5.0 PRE-APPLICATION CONSULTATION

Feedback from Coventry City Planning Department, dated 5th August 2019:

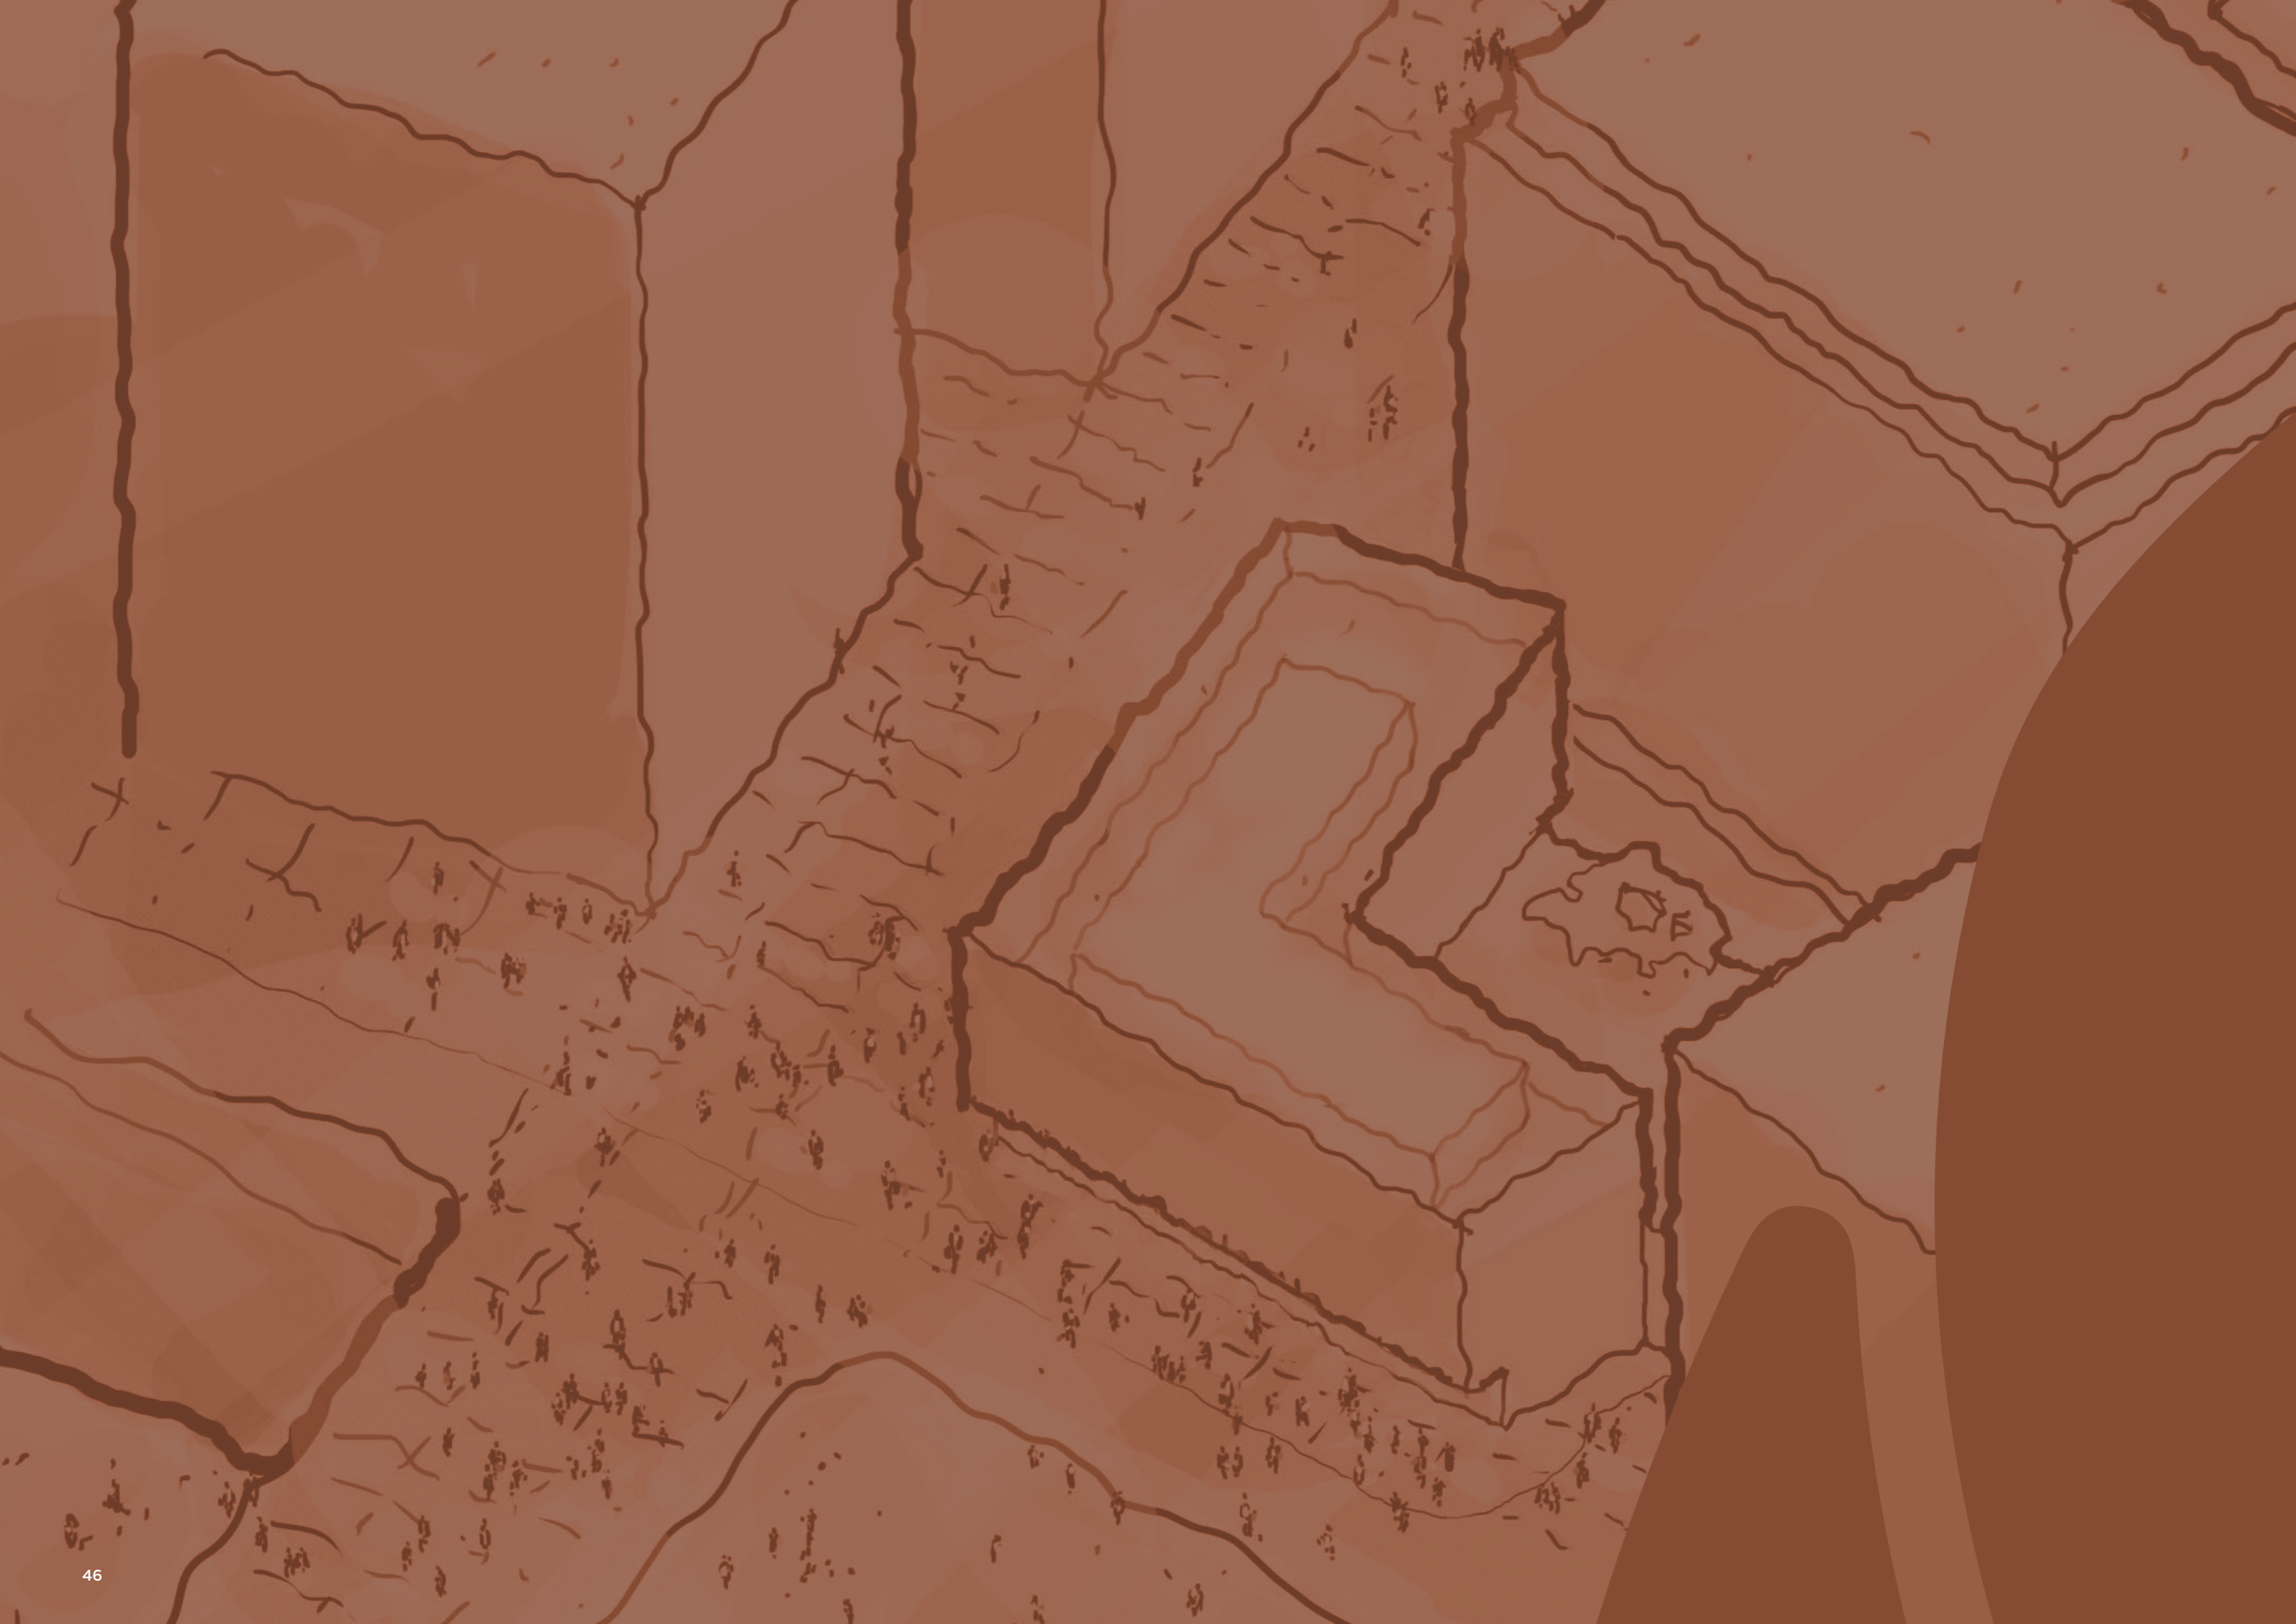
A workshop was held with representatives from the Development Management company, commissioned by Friargate JV Project Limited, to outline the design intent of the hotel. The comments received primarily focused on building mass and prominence when compared to C09.

Allies & Morrison, the masterplan architects, were mindful that the proposed height and shear mass of the building is not the same as its current neighbour and it was requested that, if this was to be the case, the hotel should have a unique design rather than attempt to mimic the grid-like nature of C09.

[Comment made during consultation 2019]
